COMMUNITY DEVELOPMENT DEPARTMENT REPORT

HEARING 9/17/2026

SUBJECT: West Ada – ALT, AZ, CUP, MDA, RZ
H-2026-0041

LOCATION: 215 and 335 S. Locust Grove Road; a portion of the NE ¼ of the NE ¼ of Section 18, Township 3N, Range 1E, parcels: R4833780200, S1118110090 and S1118110071

G. Proposed Fencing

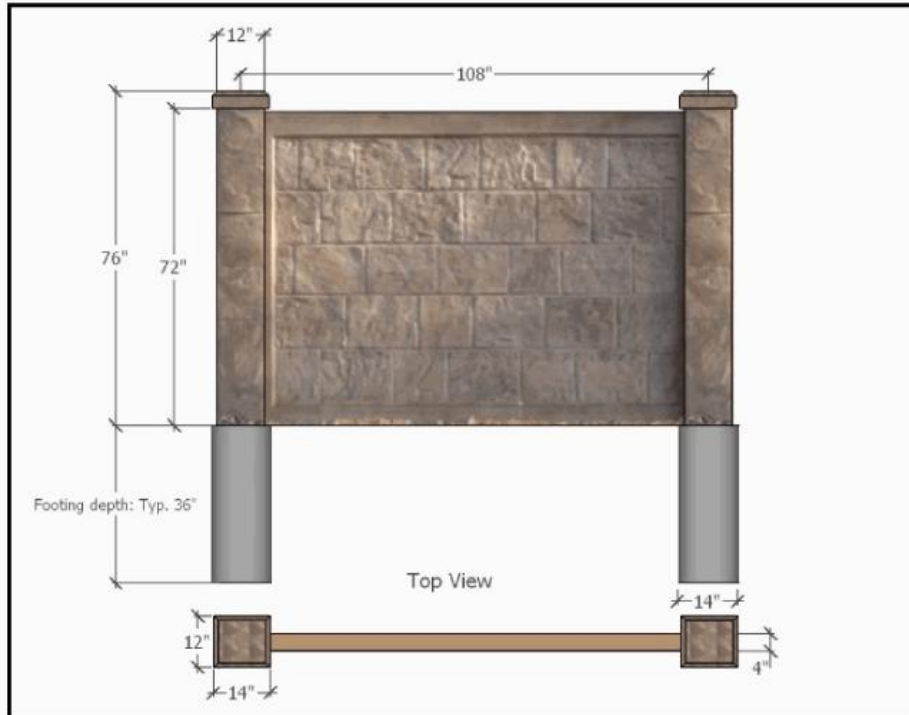
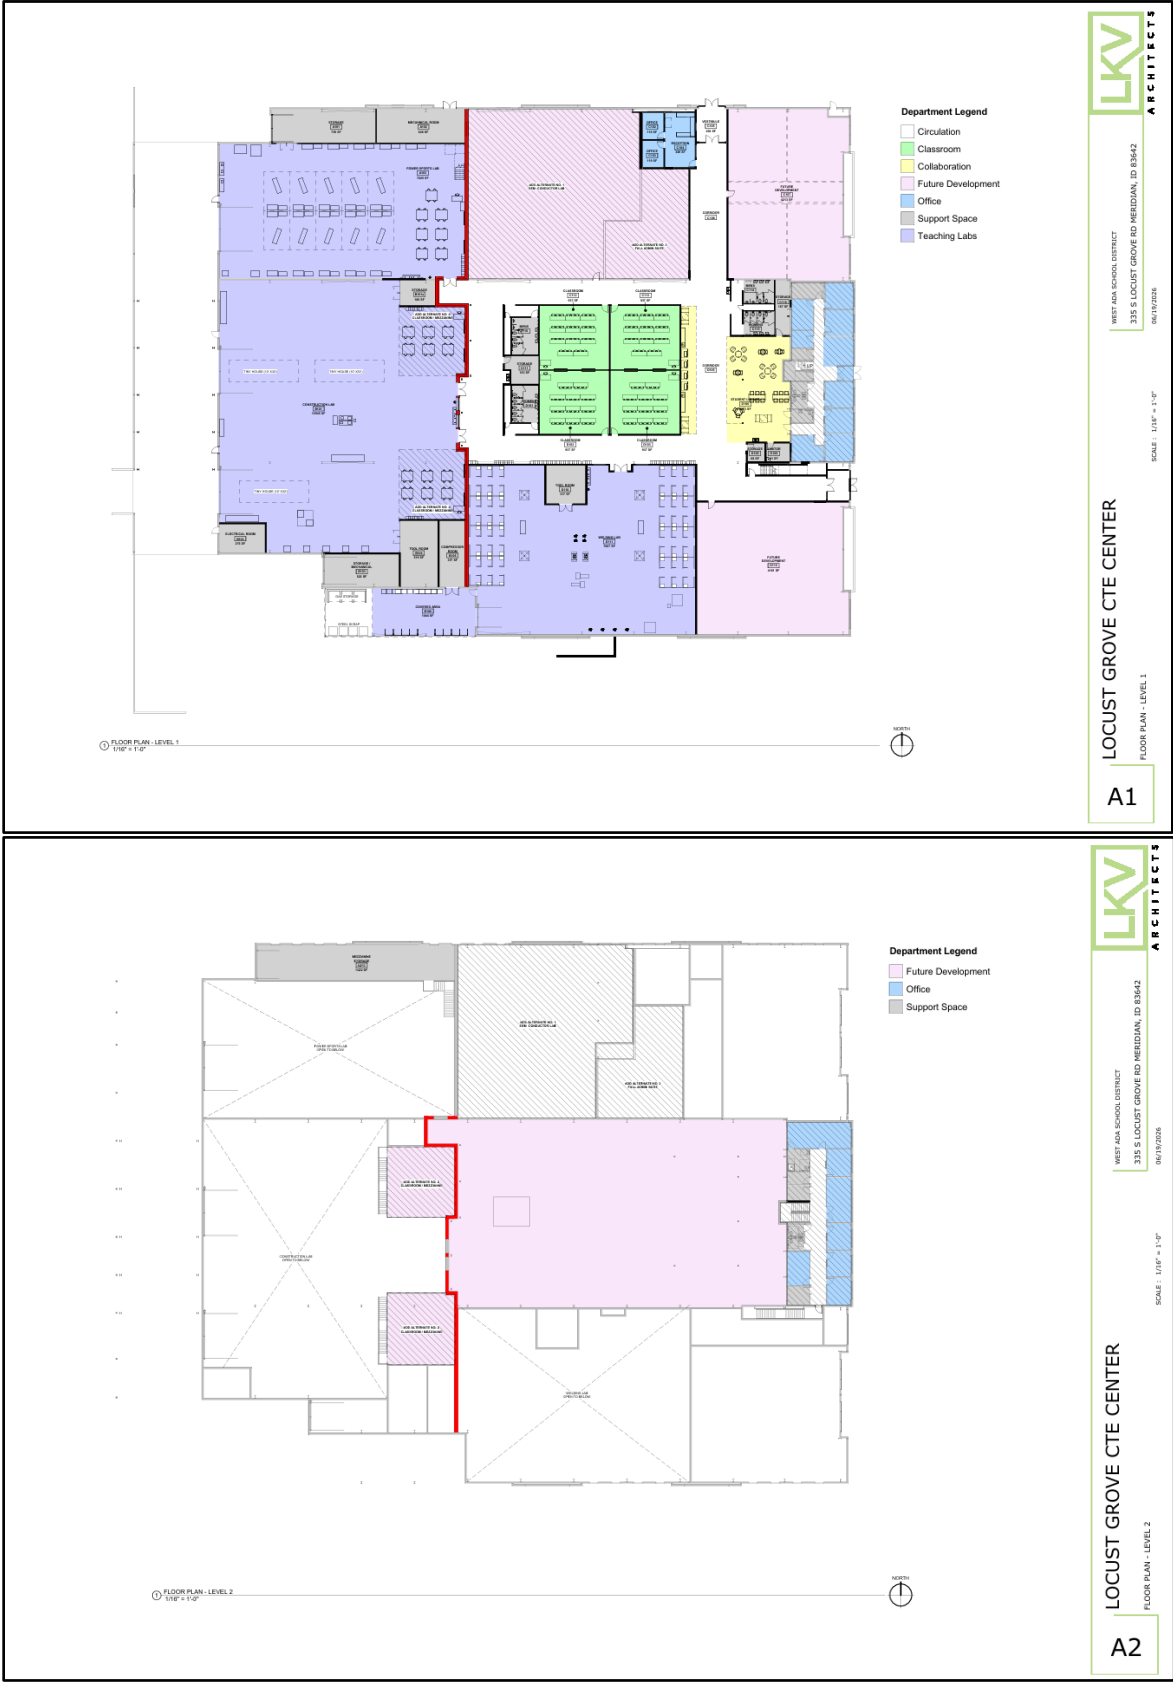
Southern Boundary 5-Foot Parking Lot Landscape Buffer Alternative Compliance Request:

As an alternative to the landscape buffer, West Ada School District proposes constructing a 6-foot concrete wall along the southern property line. The proposed wall will provide a defined separation between the school campus and adjacent property while maintaining privacy and enhancing the security of the school site. It will also allow the District to preserve the required fire lane and provide appropriate access to the mechanical equipment for ongoing maintenance and servicing.

The applicant is proposing six-foot wall along the southern property boundary and a 6-foot chain link fence with privacy slats along the parking lot to the north of the property. This site is very visible, and staff believes the applicant should install a more attractive fence than what is proposed. Staff has in previous developments approved black vinyl coated chain link with no slats.

7. The final landscape plans shall be submitted with the Certificate of Zoning Compliance shall provide the following:
 - a. The applicant shall provide a black vinyl coated fence without slats or construct a solid vinyl or wood fence. Provide fence details
